Appendix 11

Please see below my letter of objection with supporting details to the proposed applications at Meadowbank View and Meadowbank Gardens, Wellbank for road Construction Consent. Ref 145271-1002-A_RCC Application Sht 2 Meadowbank View & 145271-1001-B_RCC Application Meadowbank Garden, received from Andrew Barnes, Team Leader – Traffic, Angus Council on the 15/11/21.

Figure 1

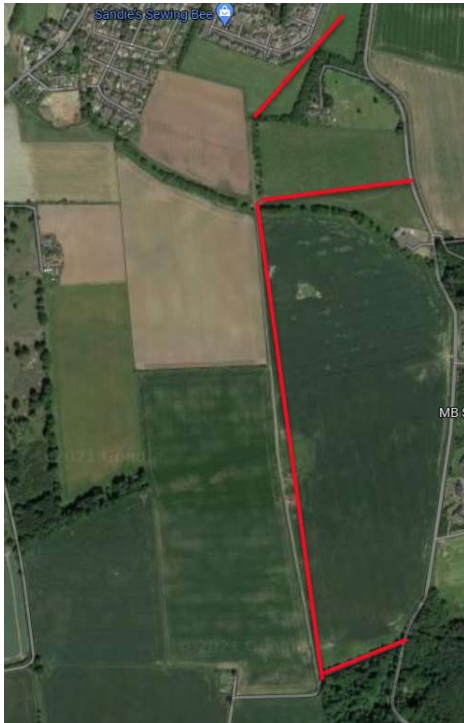
- The existing field has not been accessible through the village of Wellbank since the mid 1990's when the Meadowbank View and Gardens houses were constructed. Since that time access has been gained via the 3 routes shown in Fig 1 (on page 2) via existing farm tracks and crossing other fields. I'm not aware of any reason additional access routes would be required.

- To get to the 2 proposed new entrances, would require large agricultural machinery to be driven from the main B978 Kellas road, through Gagie Bank and into Meadowbank Gardens/View (shown in fig 3). This are is a solely residential area and the roads are small, have numerous tight turns and parked cars on them at all time. This makes it unsafe and unsuitable for large machinery to be using them especially when suitable alternatives are already available (shown in fig 1.)

- The village roads mentioned above roads are all used by the many local parents & children walking and cycling to the Mattocks primary school. It would be unsafe, dangerous, and unsuitable to have large, agricultural machinery sharing the same roads when suitable alternatives are already available (shown in fig 1.)

Figure 2

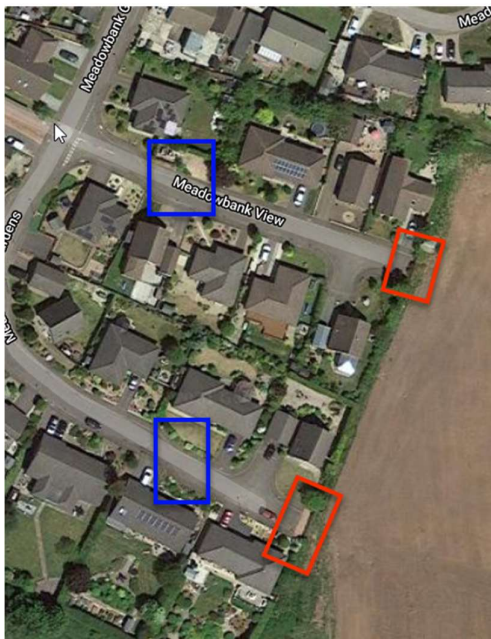
- Both Meadowbank View and Gardens are small residential cul-de-sacs and have sections of road where they narrow to single lane (shown in the blue boxes fig 2) which are unsuitable for large agricultural machinery when suitable alternatives are already available (shown in fig 1.)

- The applicant has requested 2 new accesses within 200m or each other on the same side of the field shown in the red boxes in fig 2 (at the end of this document) which seems excessive when suitable alternatives are already available as shown in fig 1.
